SEWAGE DISPOSAL SYSTEM

P 46938
A REPAIR

ADDRESS 4647 Manor Lane, Ellicott City, Maryland 21043 PHONE 465-6878

RE: Percolation Test Potential for New SFD
11489 Frederick Road
Tax Map 16, Parcel 144

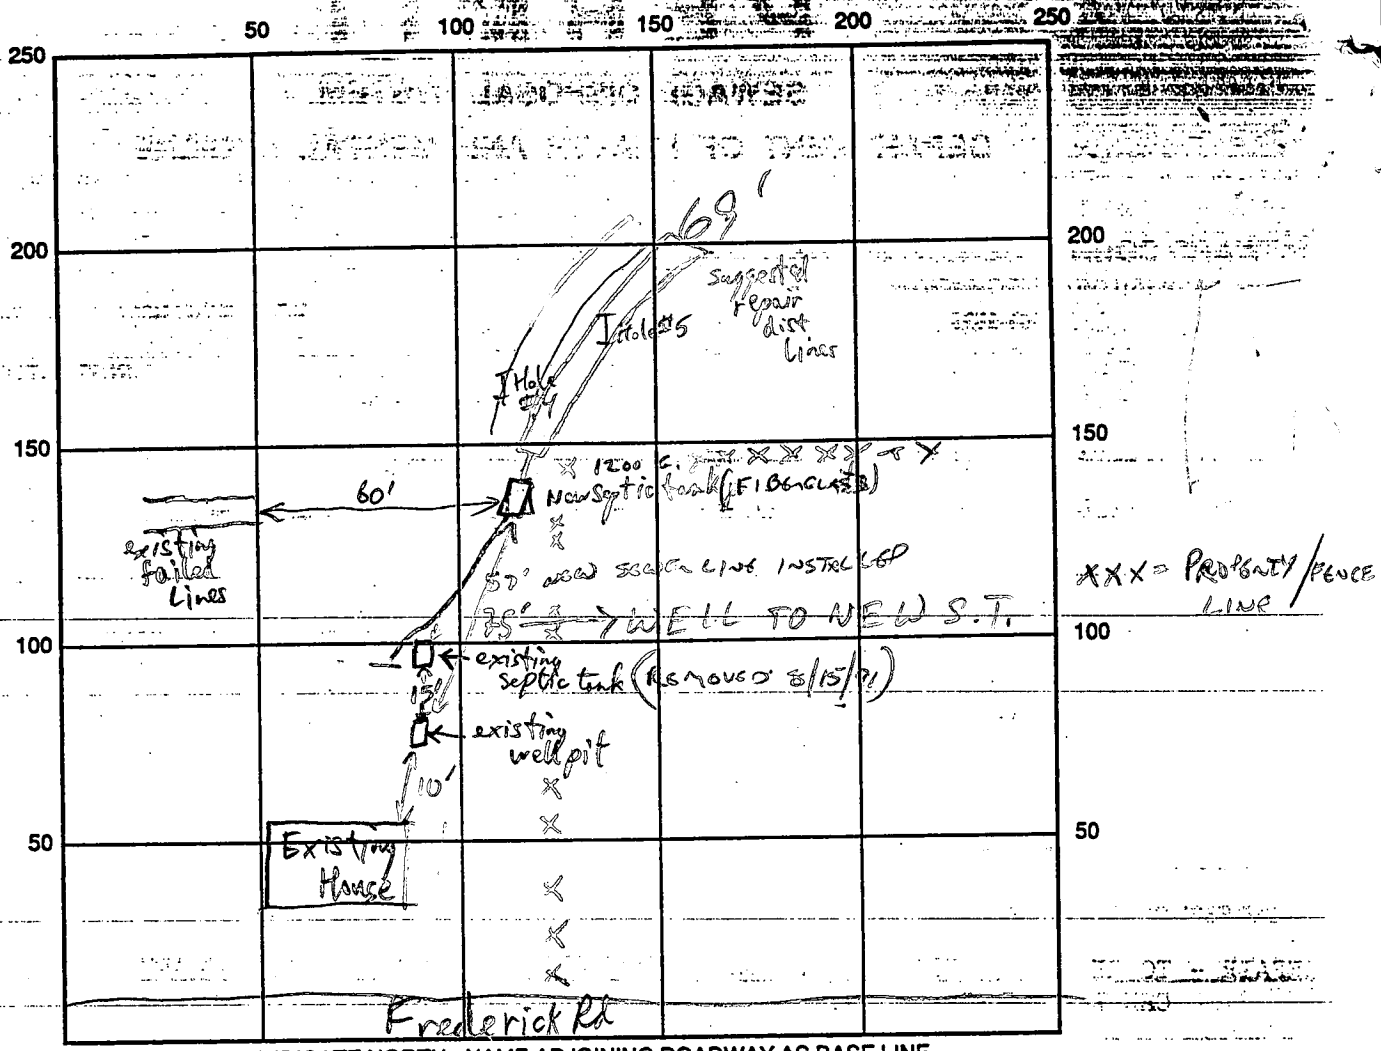
REPAIR - TO REPLACE SEPTIC TANK. CALL FOR INSPECTION WHEN GROUND IS OPENED SO SANITARIAN CAN RECOMMEND REPAIR.

Recommended situating a water tight septic tank near Hole #1 and as far from (50ft minimum) existing well permit as possible. (Abandon & fill existing septic tank.) Install as much of 100 linear feet of 2ft wide trench as possible in area on hillside around Hole #5 & Hole #4. Trench should be 5 ft deep, with 3 ft of fill stone below drain pipe. RL/cw

REMARKS: OK TO EXP. THROUGH TO APPROX. 60' AND GRAB SOIL AND CALL FOR FINAL.

WASHING MACHINE TUB TO BE EACH REPLACE MOUNT. SEPTIC SYSTEM, OK TO

REPLUMB TO ORIGINAL DISPOSAL AREA AND ADD ADDITIONAL DISPOSAL CAPACITY 8/15/91 (CW)

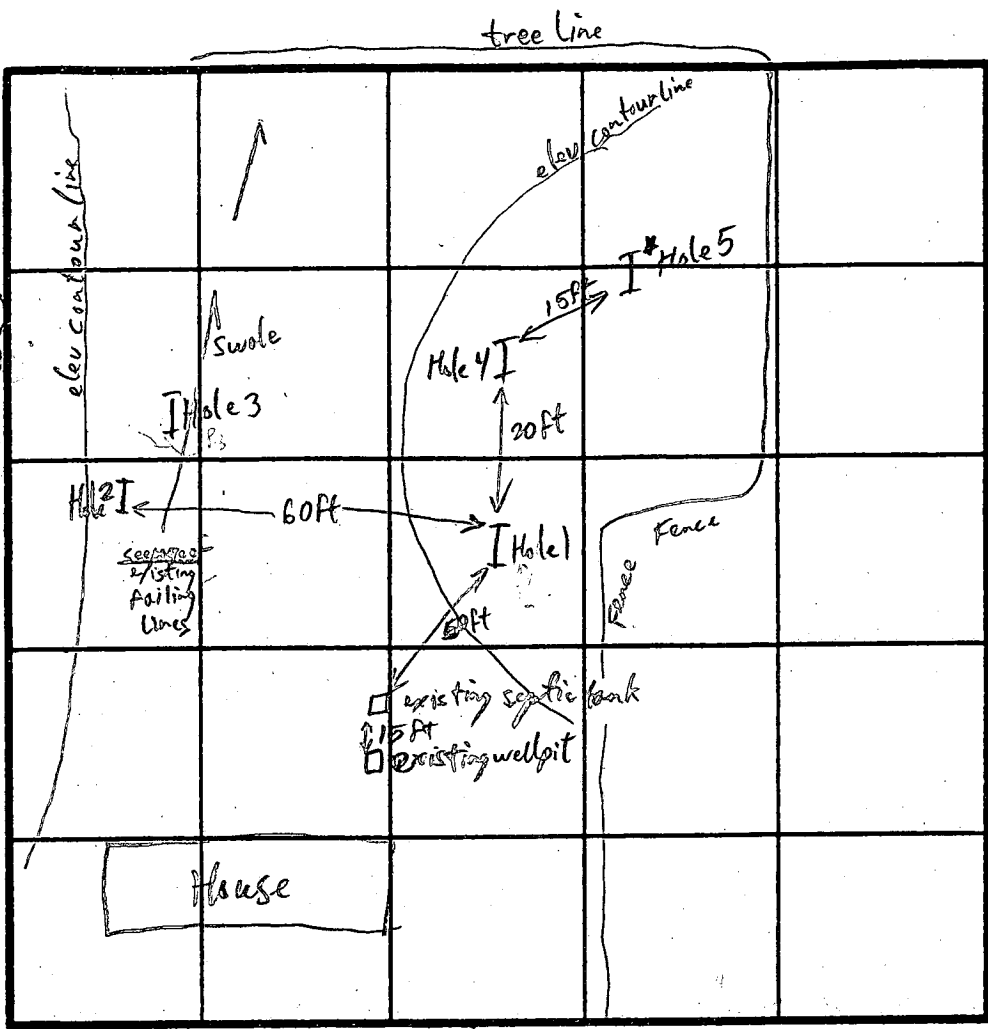
REASONS FOR REJECTION OR HOLDING Install as much of disposal system as possible in area of Hole #5 - Place a topseam or water tight septic tank (Fiberglass suggested by installer) as far as possible from existing well pit that still provide gravity flow to drain lines.

* Note - In Hole #1, very structured saprolite (deeps toward well) could be a problem if sewage leaks from tank with well only 60+ feet away.

REMARKS Area around Hole #5 is most suitable - install advised to put in as much system as he could fit - close to 300 sq ft's id would ideal (per cw)

Location Drawing

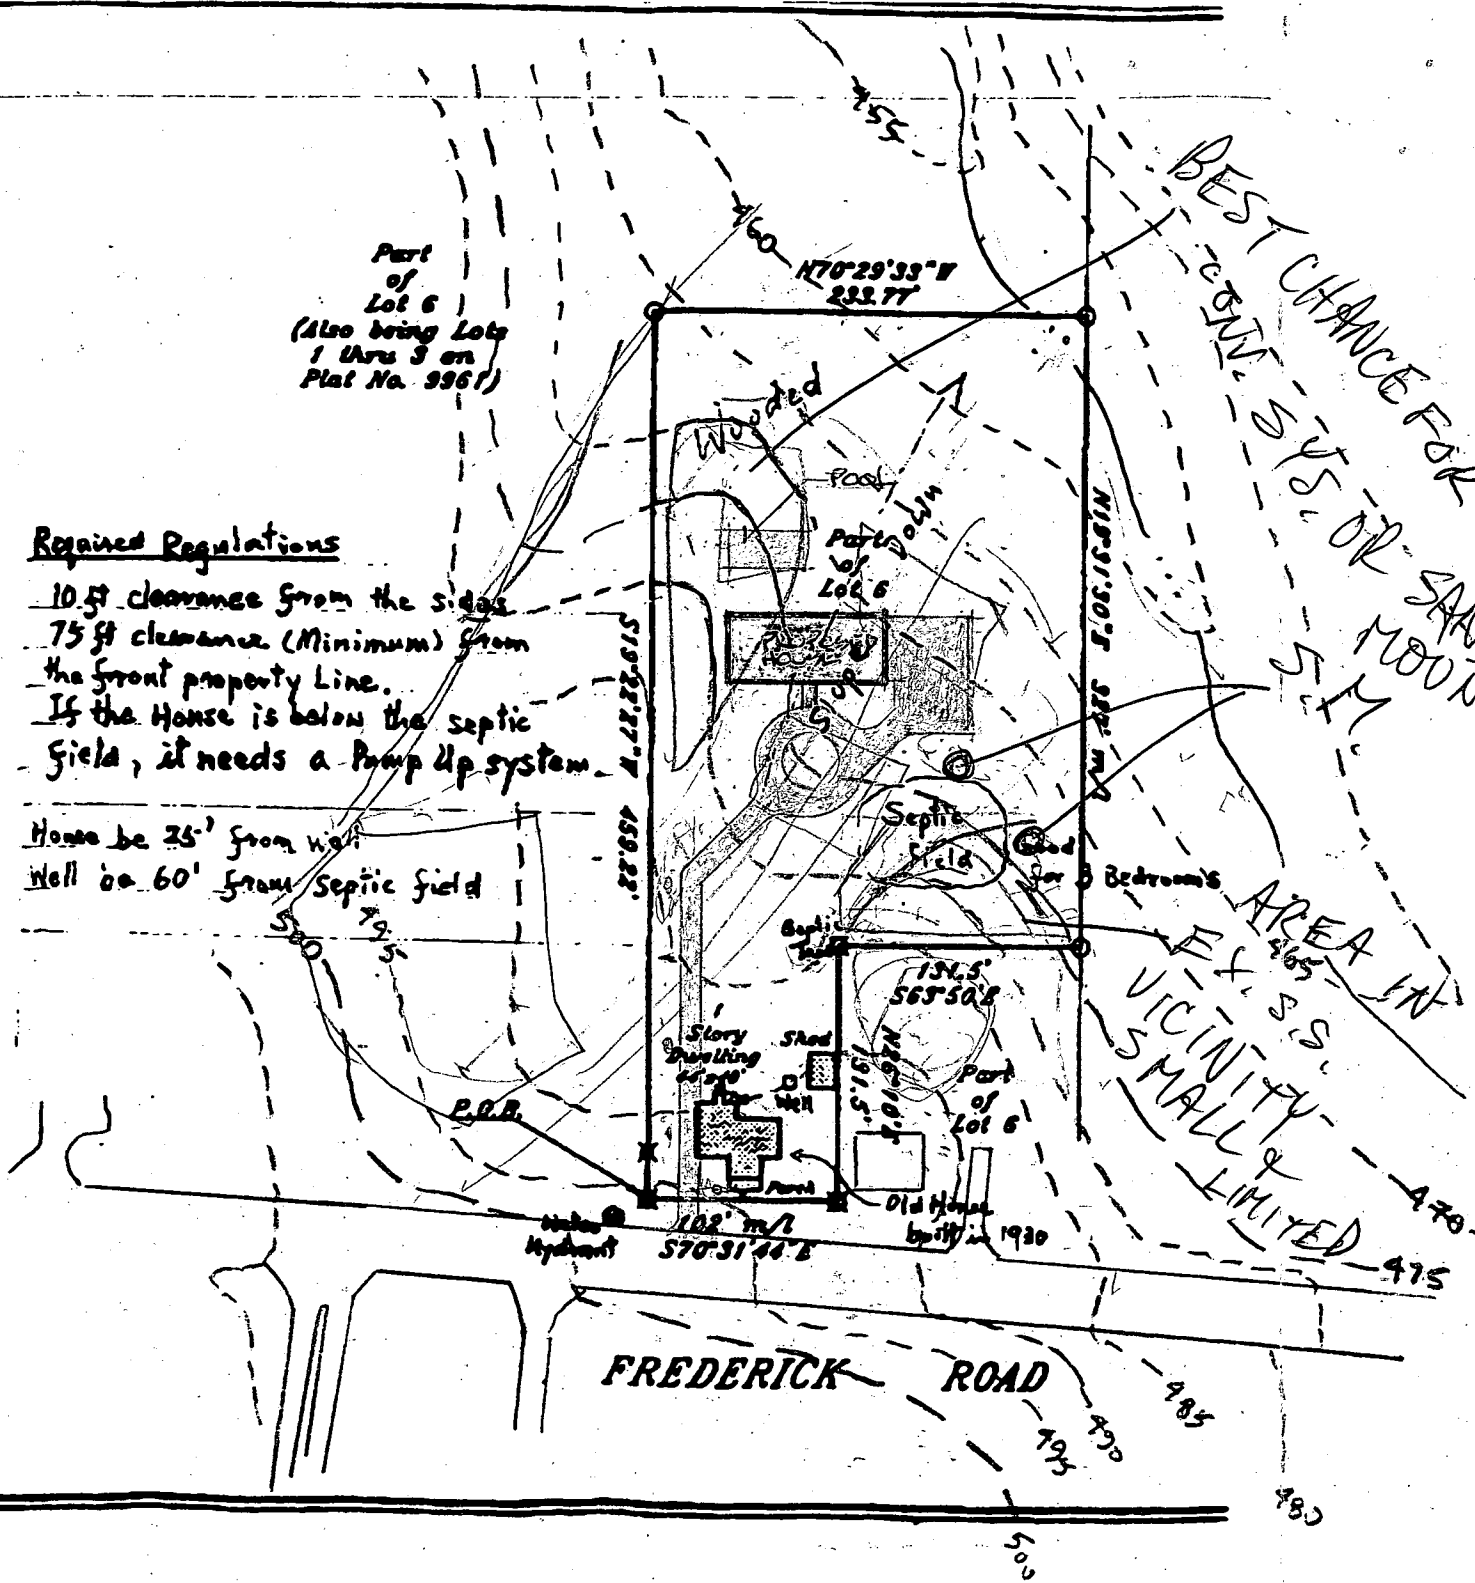
Required Regulations

- 10 ft clearance from the sides
- 75 ft clearance (Minimum) from the front property line.
- If the House is below the septic field, it needs a Pump Up system.

House be 35' from well
Well be 60' from Septic field

ACCURATE TOPOGRAPHY & SOIL TYPES w/ 2' CONTOURS

EX. HOUSE, WELL, SEPTIC

PROP. HOUSE, WELL, SEPTIC LENGTH ENOUGH FOR 2 SYSTEMS

ADJ. WELLS/SEPTICS

BEST CHANCE FOR

1 SAND MOUND, SAND MOUND, AND

1 TRENCH SYSTEM OR

2 TRENCH SYSTEMS OR

AREA IN VICINITY SMALL & LIMITED
